Re: Crownpoint Health Care Facility - Medical Gas Upgrade Code Review Report

Per the request of Rock Gap Engineering (RGE), Wilson & Company, Inc., Engineers & Architects (Wilson & Company) has reviewed the Crownpoint Health Care Facility Medical Gas Upgrade Construction Documents (Indian Health Service Order No. HHSI16103024) dated August 10th, 2018, and conducted a field investigation at Crownpoint Health Care Facility located at Highway Junction 57, Route 9 in Crownpoint, New Mexico 87313 on May 21st, 2024, to verify existing conditions of the medical gas system.

CROWNPOINT HEALTH CARE FACILITY
MEDICAL GAS UPGRADE
FOR
INDIAN HEALTH SERVICE

MG-2

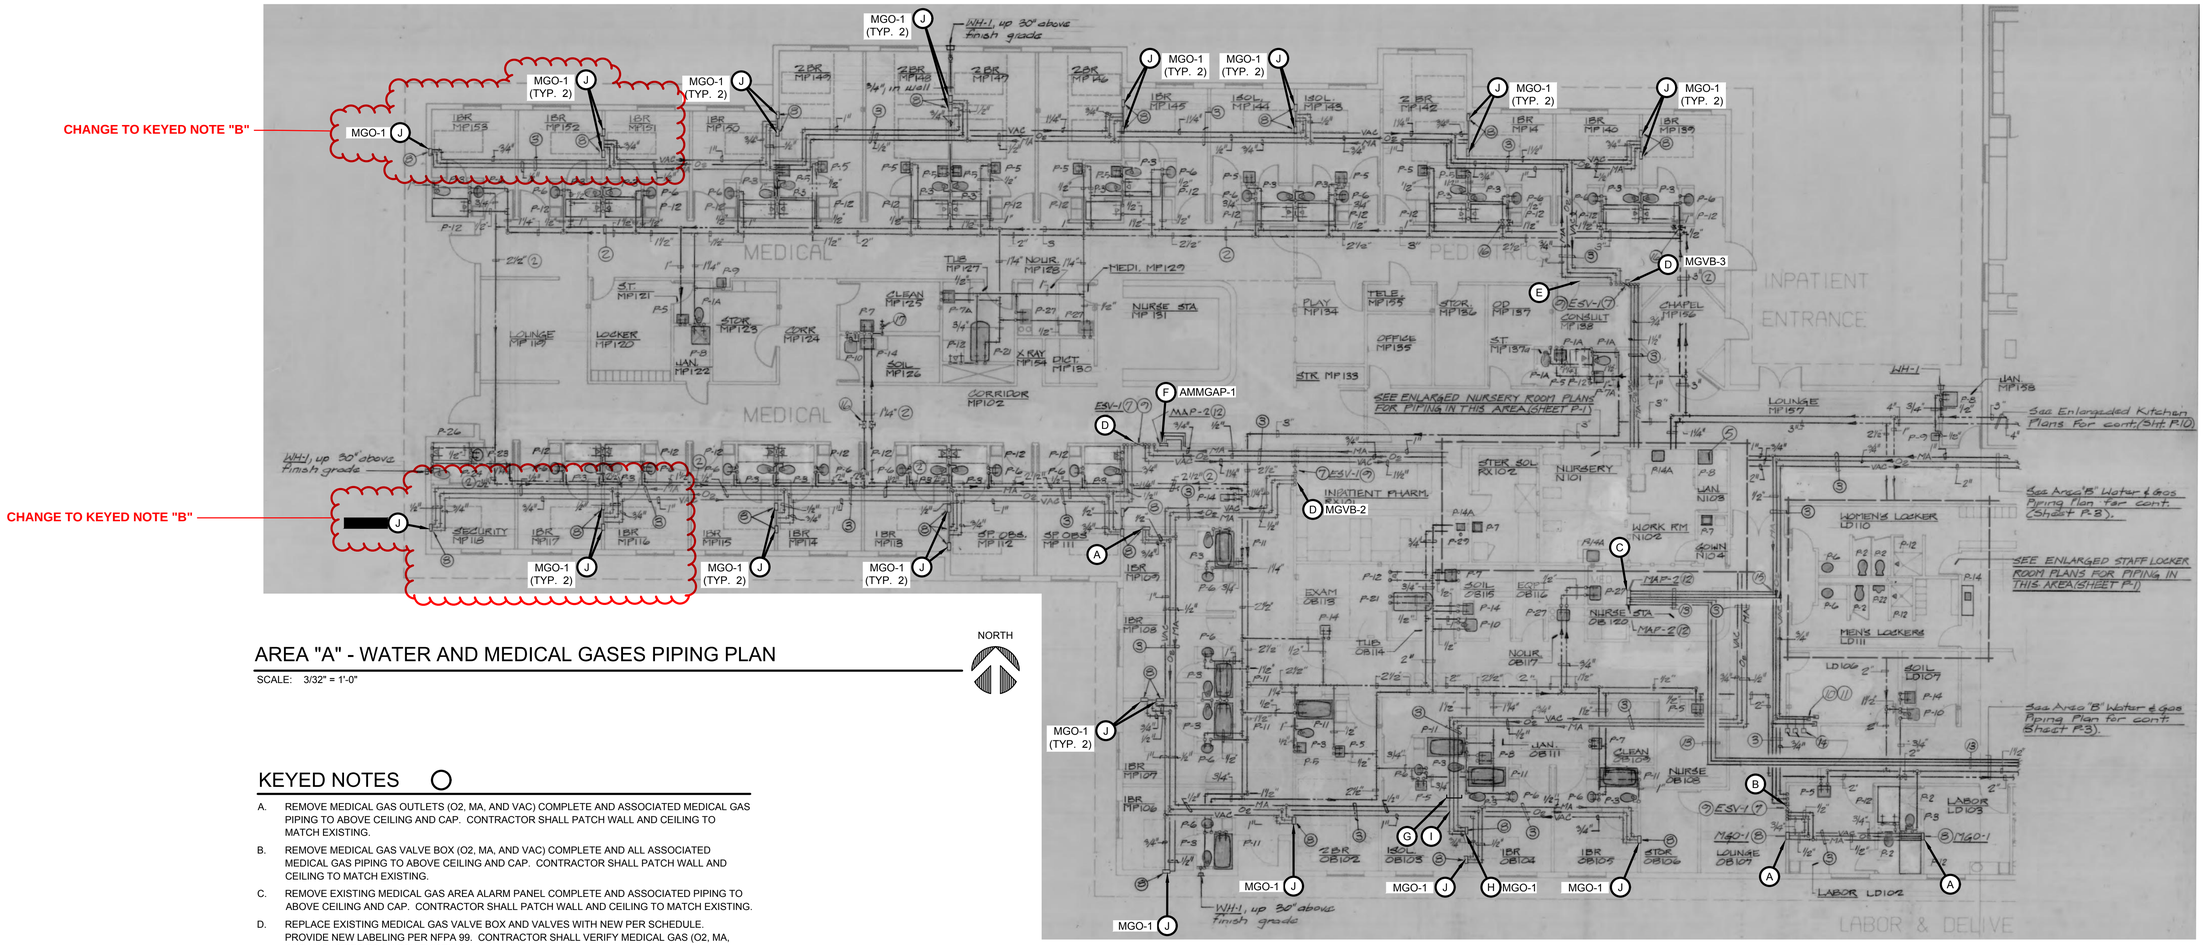
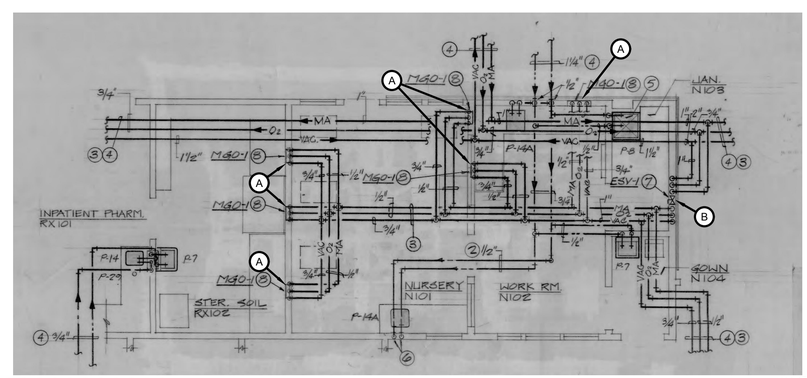
a. During site visit on May 21st, 2024, Nathaniel Morris (IHS) advised that the medical gas outlets (MGO-1) in Rooms MP117, MP118, MP151, MP152, and MP153 should be removed and capped in the ceiling space, not replaced because these spaces are no longer used as patient room. As directed by Mr. Morris, the scope of work identified in the Construction Documents for Rooms MP117, MP118, MP151, MP152, and MP153 should be revised accordingly in these spaces.

b. The Nursery Room area has been updated to Women's Health Clinic.

MG-4

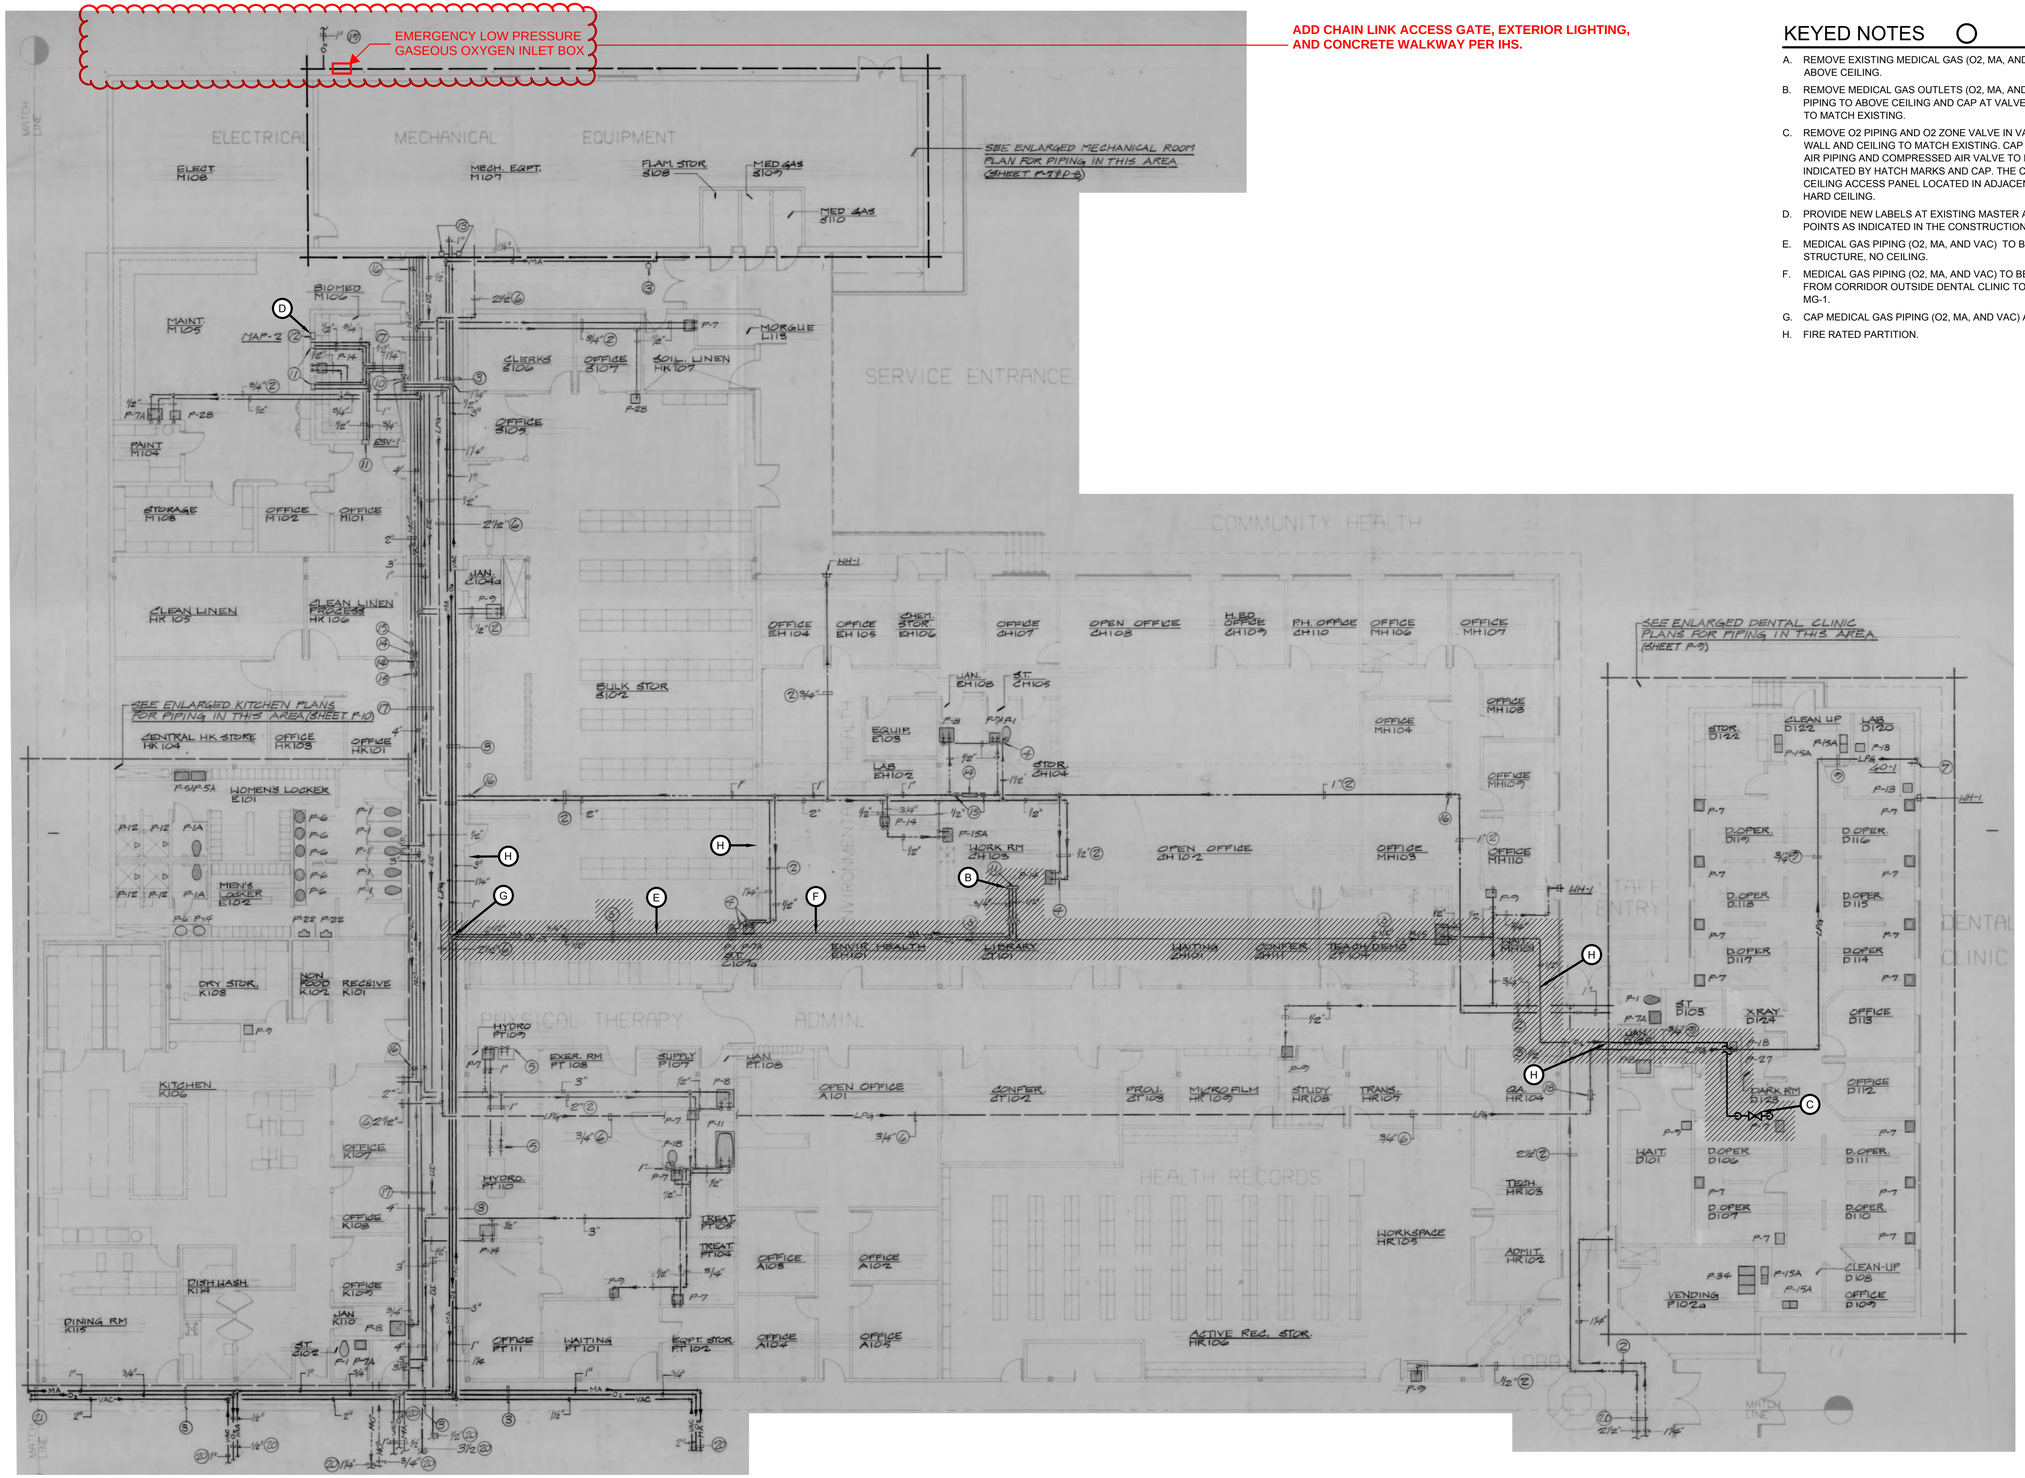
a. An emergency low pressure gaseous oxygen inlet box has been added on the exterior wall of Area "C" since the Construction Documents were issued on August 10th, 2024, and it is recommended that the addition of this equipment be indicated on this plan.
i. Reference Attachment 2.

b. During site visit on May 21st, 2024, Nathaniel Morris (IHS) advised that the following items need to be added to this area:
i. A chain link access gate should be added to the west of the emergency low pressure gaseous oxygen inlet box,
ii. Additional exterior lighting be added above the emergency low pressure gaseous oxygen inlet box, and
iii. A concrete walkway for access from the chain link access gate to the emergency low pressure gaseous oxygen inlet box.

PARTIAL POWER PLAN OF MECH EQUIP ROOM 107

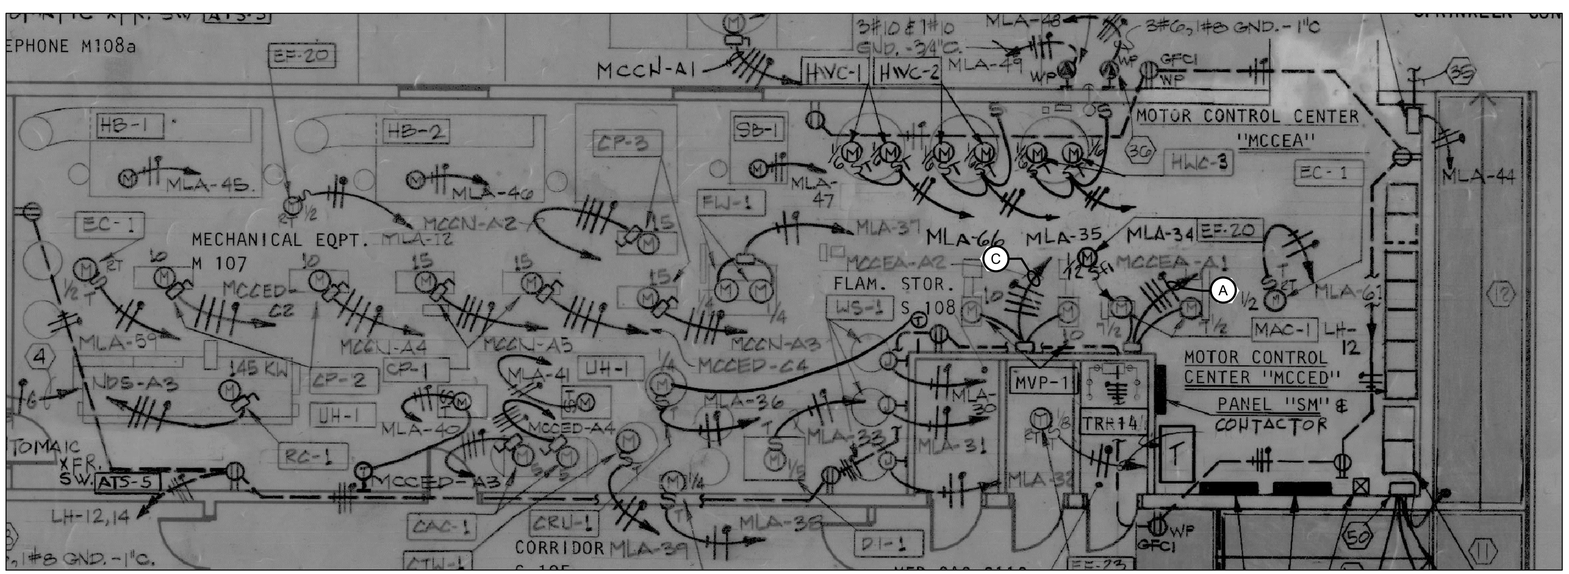
7. **Sheet E-1**
    a. In review of the updated mechanical equipment data, site evaluation, and Medical Gas Upgrade Construction Drawings dated August 10th, 2018, there are no impactful electrical code changes that will result in substantial modification to the electrical design. However, there are discrepancies noted in the information on the Medical Gas Upgrade Construction Drawings and original Record Drawings included on this sheet. This would include wire size verification/replacement and circuit breaker replacement by the Contractor.

b. The Medical Gas Upgrade Construction Drawings are calling out motor circuit protectors (MCPs) which are typically used when connected directly to motors as part of a motor starter or variable frequency drives (VFDs). Under this scope of work the Contractor will be connecting to UL rated panels, so thermal magnetic breakers are recommended in lieu of MCPs. MCPs are the similar, but only contain overload elements, whereas thermal magnetic breaks have both overloads and short circuit protection.

c. Medical air compressor (MAC-1):
        i. Two (2) 7.5 HP motors are indicated on E-1 and match the field verified equipment.
        ii. The updated medical air compressor contains two (2) 5 HP motors.
        iii. The Record Drawings show conflicting wire size between the schedule and plan view; a #10 minimum conductor is required. This will require field verification and possible replacement if wire size is smaller than #10.
        iv. The Record Drawings indicate a motor circuit protector is installed currently. The new equipment needs to be protected by thermal magnetic breaker. A new 25A, 3P circuit breaker will need installed in MCCEA-A1. Eaton FDC3025 or equal. Compatibility must be field verified prior to ordering.

v. During the site visit it was noted that the motor circuit protector (MCP) for MVP-1 was locked out/tagged out and this unit was not operating.

1. Reference Attachment 2.
    d. Medical vacuum pump (MVP-1):
        i. Two (2) 10 HP motors were noted on the field verified equipment nameplate and (2) 5 HP motors indicated on Sheet E-1.
        ii. The updated vacuum pump (MVP-1) skid contains two (2) 7.5 HP motors.
        iii. As-built drawings show conflicting wire size between the schedule and plan view. #10 minimum conductor is required. This will require field verification and possible replacement if wire size is smaller than #10.
        iv. As-built drawings indicate a motor circuit protector is installed currently. The new equipment needs to be protected by thermal magnetic breaker. 30A, 3P circuit breaker needs installed in MCCEA-A2. Eaton FDC3030 or equal. Compatibility must be field verified prior to ordering.
